VIRTUAL MEETING OF THE BIRMINGHAM PLANNING BOARD
WEDNESDAY, SEPTEMBER 23, 2020
7:30 PM

SUBJECT: 768 N. Old Woodward – The French Lady – Special Land Use Permit & Final Site Plan Review

SUBJECT: 469-479 S. Old Woodward – Project M1 – Final Site Plan & Design Review (5-Story)

768 N. Old Woodward
The French Lady
*Special Land Use &
 Final Site Plan Approval*

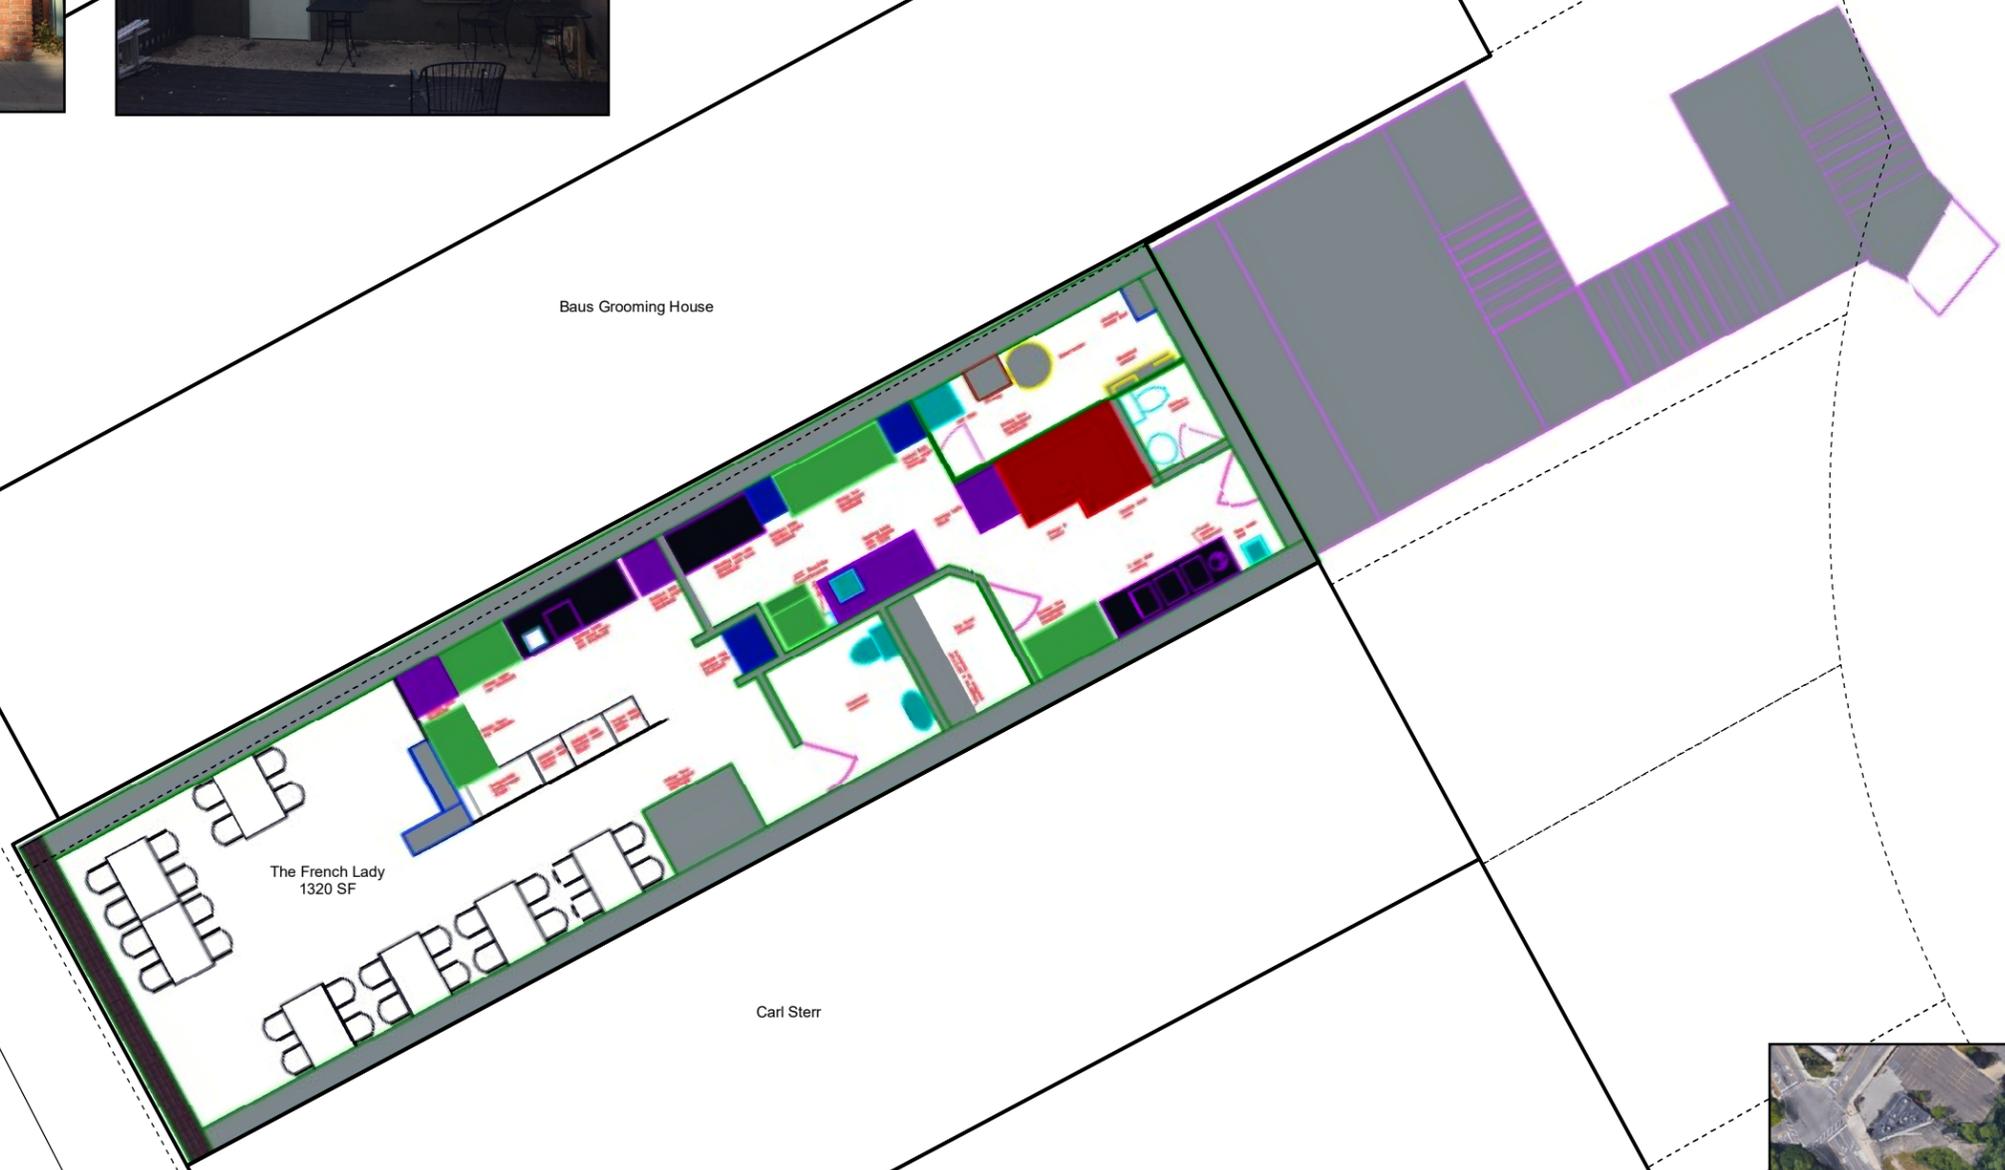
- 3.1 Dumpster Screening – The applicant has stated that although there are no waste receptacles on site, they have secured dumpster privileges with One Source Waste for the common dumpster in the rear public parking lot area. **The Planning Board may wish to require the applicant to screen the shared dumpster.**

- 3.3 Mechanical Equipment Screening – There are no changes proposed to the existing rooftop units, nor are any new rooftop or ground mounted mechanical units proposed. **The Planning Board may wish to require the applicant to screen the existing rooftop units.**
